HALSNEAD PARK (PHASE 1), WHISTON
FOX CLUMP WOODLAND FOOTPATH
ARBORICULTURAL IMPACT ASSESSMENT ADDENDUM
November 2024

Document Title	Arboricultural Impact Assessment Addendum
Prepared for	Taylor Wimpey North West
Prepared by	The Environment Partnership (TEP) Ltd
Document Ref.	7137.08.001
Date	November 2024
Author	Heather Eilbeck
Checked	Robin Grimes
Approved	Jonathan Smith

Proposed Development Amendment

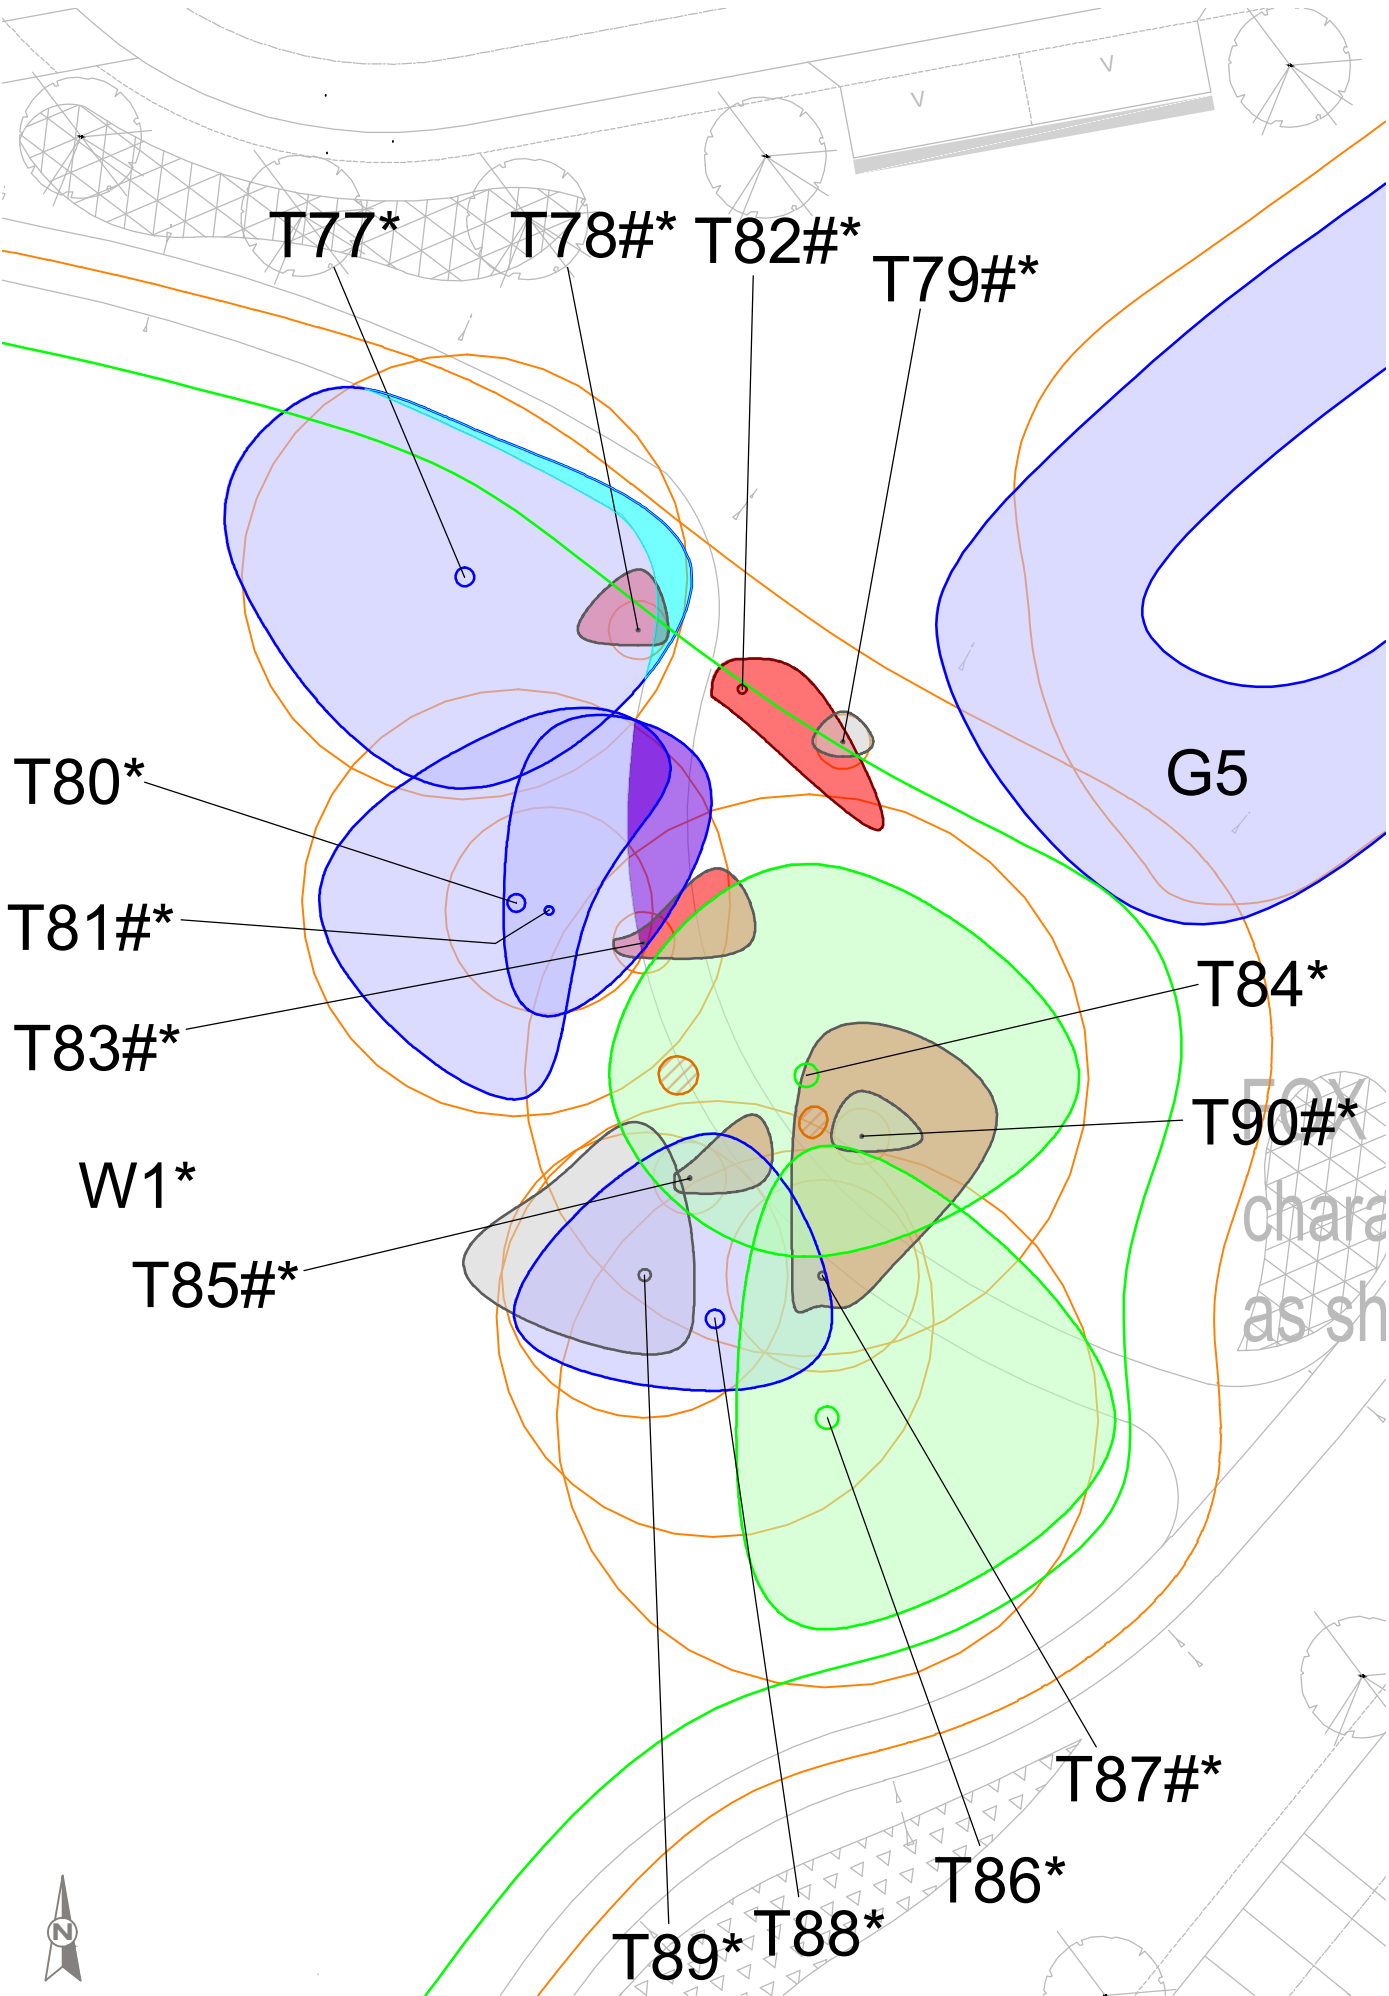
- 2.4. The proposed changes involve an amendment to the alignment of a proposed footpath around the edge of W1. This footpath was proposed around the perimeter of the woodland but, due to clashing with the edge of an existing pond (surrounded by G5), it has now been redesigned to cut through W1. The amended footpath alignment is shown opposite and based on the Planning Layout Plan (ref: 20285-PLA-01-X).

- Impact Assessment**
- 2.6. The proposed new footpath alignment would necessitate the removal of five trees and two small understorey trees (less than 75mm diameter). Of these, four are of low quality (Category C; T78, T83, T85 and T87) and one is of poor quality (Category U; T82).

- 2.7. The updated footpath alignment has targeted areas of open space within the woodland understorey and has been designed to avoid any requirement to remove large and/or high quality trees. Those proposed for removal are small self-set trees of low quality, one of which has already failed at an included basal union (T87) and one of which is dead and has failed onto the woodland floor (T82). Their removal would result in a small reduction in habitat, but this would be of little consequence in terms of detriment to arboricultural, landscape or habitat value of the woodland as a whole.

- 2.8. The partial removal of moderate quality (Category B) group G5 would no longer be required to accommodate the proposed footpath at the amended alignment and could be retained in full.

- 2.9. Three trees would need to be pruned to accommodate the amended footpath alignment. The north-eastern canopy edge of T77 would need to be crown reduced by c. 1.2m prevent it from overhanging the footpath. The north-eastern canopies of T80 and T81 would need to be crown lifted to 4m to ensure adequate vertical clearance over the footpath. Pruning in all instances is relatively minor and would not result in long term detriment to affected trees.
